# **PROPOSED ELECTRIC VEHICLE CHARGING POINT PARKING SPACES IN DE FREVILLE AVENUE AND RIVERSIDE AREAS, CAMBRIDGE**

## **WRITTEN REPRESENTATIONS RECEIVED**

### **Suggestion 2: Release other pay & display spaces for resident parking, to replace those removed.**

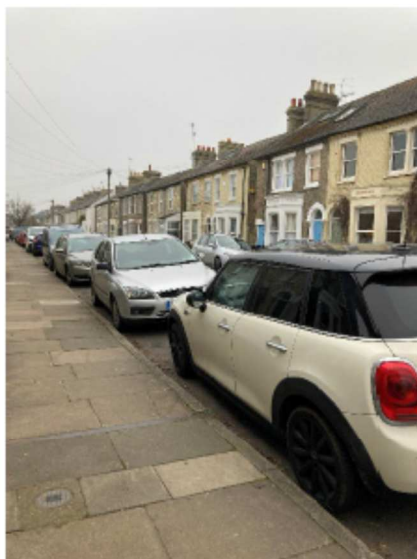
The TRO proposes converting six resident parking bays to EV charging bays. However, charging bays are not parking spaces. EV owners will be expected to vacate bays once charged and park elsewhere. The difficulty is that all Riverside CPZ parking spaces are fully occupied most of the time, as recent easyHotel traffic analysis showed, and as the photos on the next page confirm.

We therefore request that if resident bays are removed, an equivalent number of nearby pay & display spaces should be converted to resident parking.

There is a substantial volume of pay & display provision in Riverside area which is almost entirely unused. Photos taken on a typical weekday show empty pay & display bays in Beche Road, Saxon

### **Suggestion 3: Protect riverfront safety and amenity by not installing new EV charging bays on it**

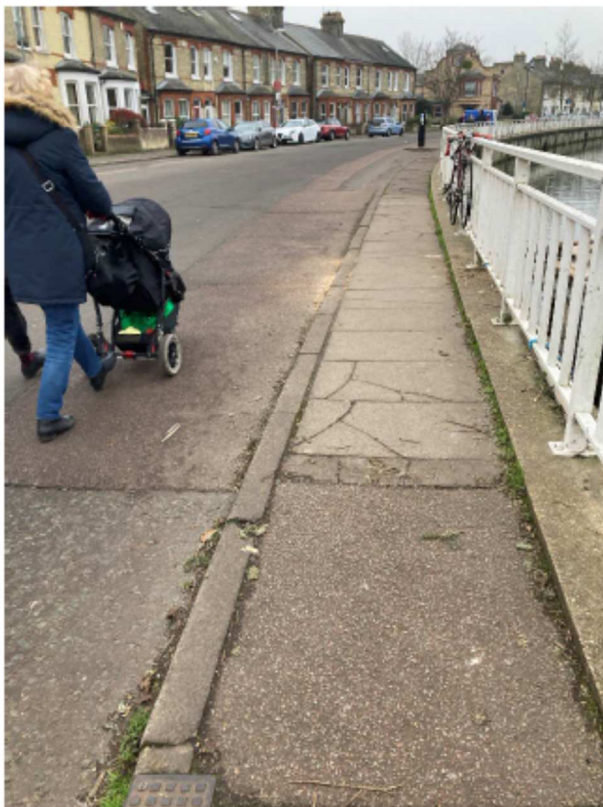
The pay & display bays along the Riverside riverfront are as underused as other local pay & display, and therefore generate very few vehicle movements. New EV charging bays will attract vehicles to the riverfront, whether residents charging or others seeking free parking (see point 4 below).

We feel the incremental value of two riverfront charging bays is low, given 18 other charging bays are proposed (including in Abbey Road car park) and potential for other bays in less-contested locations. Encouraging EV owners to charge up on the riverfront is undesirable for two reasons:

- i. Cars entering, parking in and leaving charging bays will obstruct the riverfront walking route and increase conflict risks. Riverside is a busy pedestrian and cycle route, and most pedestrians choose to walk along the (currently) mostly car-free riverfront, as the photos below show. Government policy is to encourage highways authorities to improve cycling and walking infrastructure, with performance to be assessed by a new agency Active Travel England. Attracting vehicles onto a walking route is not an improvement.

- ii. New EV charging activity and infrastructure could prejudice the City Council's Riverside vision of a walker and cyclist-friendly "promenade" linking Midsummer and Stourbridge commons, recognised as a City-wide amenity. An outline Vision was endorsed by the City Council in 2010 and residents are working actively to shape more detailed proposals for incorporation in the next Local Plan (see Appendix A draft consultation document). To protect the vision of a promenade along the riverfront of similar width to that between Abbey Road and Priory Road, any charging bays would need to be positioned at least 3m from the fence, and the space between identified as pedestrian only. This could potentially create other issues for cyclists and vehicles travelling along Riverside.
